Access Compliance Report

Public Rights-of-Way

(Curb Ramps)

Intersection ID: 9693	Main Street: MULBERRY_AV	Cross Street: PATTON_AV	Location: SE
ADA ID: 4ECF66B64391	Ramp Type: Directional1	Initial Pass/Fail: Pass	Overall Compliance: No
Codes/Mitigation Info/Possible Solution		Field Measurements/Component Compliance	
Severity Score: 7.5

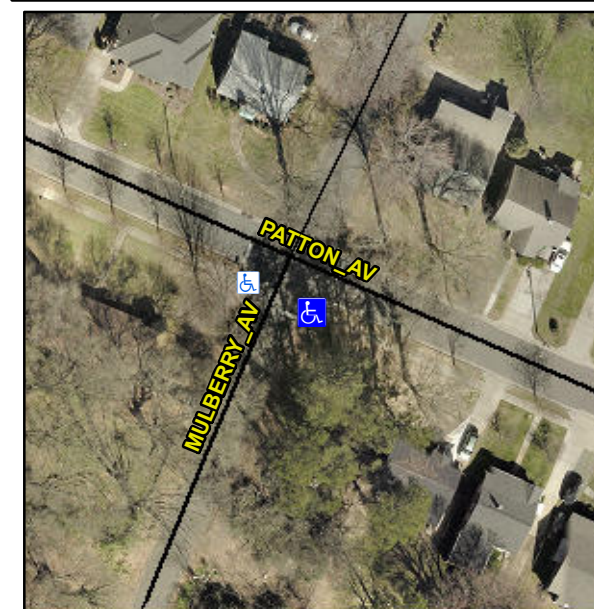
**Not Found, R304.2.2-Perp, R304.3.2-
Para, R304.5.3, R304.5.2, R305.1.4,
R305.2, R304.5.4**

Compliance	Description	Data	Compliance	Description	Data
N/A	Ramp Length (in)	106.5	No	Grade Break?	No
Yes	Ramp Width (in)	56.0	N/A	Grade Break Slope (%)	6.8
Yes	Ramp Slope (%)	5.5	N/A	Grade Break XSlope (%)	0.4
Yes	Ramp XSlope (%)	1.3			
Yes	Flare Type LT	N/A	Yes	Flare Type RT	N/A
N/A	Flare Slope LT (%)	N/A	N/A	Flare Slope RT (%)	N/A
N/A	Flare Traversable LT?	No	N/A	Flare Traversable RT?	No
Yes	Landing Length (in)	64.5	Yes	DWS Provided?	Yes
Yes	Landing Width (in)	57.5	Yes	DWS Contrast?	Yes
No	Landing Slope (%)	2.5	Yes	DWS Length (in)	24.0
No	Landing X Slope (%)	3.6	No	DWS Full Width?	No
N/A	Landing Curb? (Y/N)	N/A	No	DWS Offset LT (in)	4.5
N/A	Shared Landing?	No	Yes	DWS Offset RT (in)	30.5
Yes	Gutter Ponding?	No	No	Gutter Slope (%)	6.2
Yes	Gutter Lip Ht (in)	0.0	Yes	Gutter X Slope (%)	1.7
N/A	Painted X Walk1?	No		Road Slope (%)	2.9
	X Walk 1 Direction	To NW		Road X Slope (%)	2.2
	X Walk 1 Width (in)	N/A		Clear Space?	Yes

**Remove & Replace Entire Ramp.
Remove & Replace Gutter.**
